INDESIT company

Model type:
AVSD109EU

Commercial code:
F029628

n1040325: New shock absorber fixing system with pin

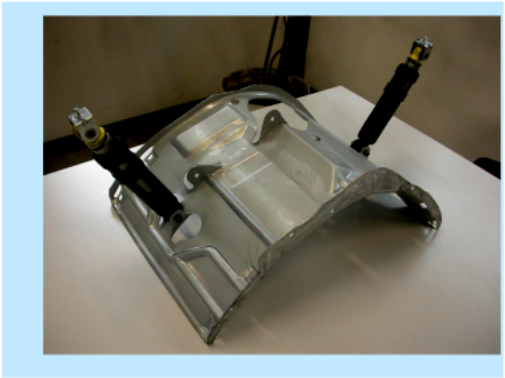
From serial no. 40427.0001, shock absorbers have been fixed to the tank unit cradle with two 11 mm pins code C00110163 (see fig. 01 and 02 enclosed) in place of the 8 mm screws code 093750 and relevant locking nuts code 030443, on all washing

machines and dryers produced in the Comunanza factory.
The items affected by this modification are:
1) The cradles have the same Service code, as they can be used in place of the new ones after widening the shock absorber fixing holes to a diameter of 10 mm.
Code 093848 - Tank unit cradle 46 lt
Code 093878 - Tank unit cradle 40 lt.
2) The new shock absorbers, with fixing bushing having no s/steel spacer, are not managed as they are interchangeable with the premodified items (make sure they are CIMA type, as the managed items), fixed with M8 screws code 093750 and related locking nut code 030443 (see figs. 05 and 06).
Code 093884 - Shock absorber 80 N
Code 093885 - Shock absorber 100 N

To remove the shock absorber from the tank, first extract the pin with a few hammer taps (see fig.03) until it is aligned with the tank bracket and then pull it out with a pair of pliers (see fig. 04).
(To refit the shock absorber use a new pin. Insert the pin until the toroidal edge is aligned with the bracket.)

n1040326: Two-bearing mechanism on Slim range washing machines

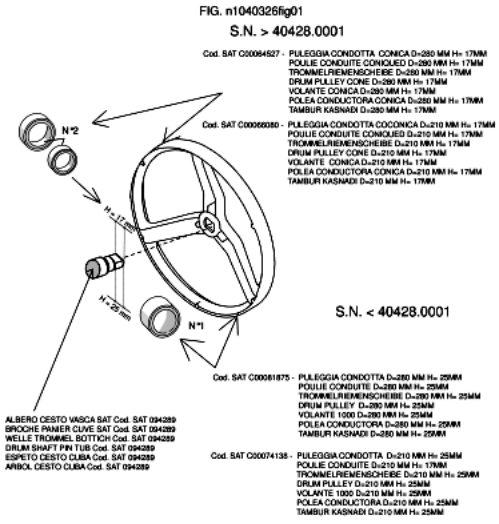
From serial no. 40428.0001, all Slim range models produced in the Comunanza factory have been equipped with a two-bearing mechanism in place of the single-bearing one.

The Service codes of the new mechanism are:
Service code C00096186 - SEAL RING CV4;
Service code C00002591 - BEARING 20X47X14 6204 SKF;
Service code C00013563 - BEARING 25 X52 X 15 6205 - 2Z SKF;
Service code C00110340 - CROSS WITH SEAL RING (2C) SNELLA;
Service code C00094289 - EVO 40L TANK SLIM (1-C) > (2-C)EVOII;
Service code C00094290 - OUTER- SET 40 L.(1-C)>(2-C)EVOII;
Service code C00064527 - DRIVEN PULLEY CONE D=280 MM H= 17MM;
Service code C00066080 - DRIVEN PULLEY CONE D= 210 MM H=17 MM.

The tank assembly with the new two-bearing cross has the same Service code as the single-bearing one (C00094289); the latter will be available until stocks run out.
When replacing the tank, make sure that the value H (17 mm or 25 mm) of the basket cross shaft corresponds to the value H of the pulley (see Fig.001).

Fig . 001

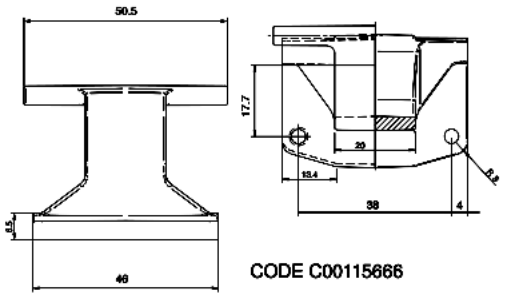
From serial no. 50207.0001, all Ariston models produced in the Teverola factory (see table 001 attached) with industrial code (given on the rating plate) starting with 46, have been equipped with a Zamac hinge with 150° opening angle, code C00115666 (see Fig.001).
This modification has involved the introduction of the following items:

Code C00115670 - Complete door EVOII 150° white 27 with standard glass;
Code C00115674 - Complete door EVOII 150° white 27 with long glass;
Code C00115667 - EVOII body for 150° hinge white 27;

The premodified items are not interchangeable separately with the modified ones.

Fig . 001

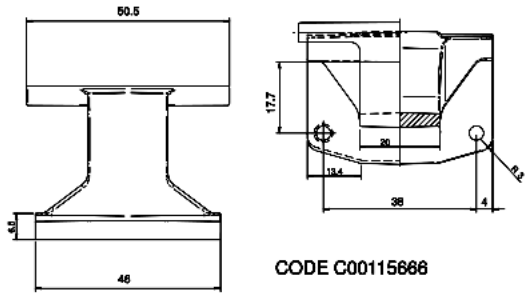
From serial no. 50207.0001, all Ariston models produced in the Comunanza factory (see table 001 attached) with industrial code (given on the rating plate) starting with 80, have been equipped with a Zamac hinge with 150° opening angle, code C00115666 (see Fig.001).
This modification has involved the introduction of the following items:

Code C00115670 - Complete door EVOII 150° white 27 with standard glass;
Code C00115674 - Complete door EVOII 150° white 27 with long glass;
Code C00115668 - Complete door EVOII 150° silver with standard glass;
Code C00115673 - Complete door EVOII 150° silver snella standard glass;
Code C00115662 - EVOII body for 150° hinge white 27
Code C00115663 - EVOII body for 150° hinge silver 27
Code C00115664 - Snella EVOII body for 150° hinge white 27
Code C00115665 - Snella EVOII body for 150° hinge silver

The premodified items are not interchangeable separately with the modified ones.
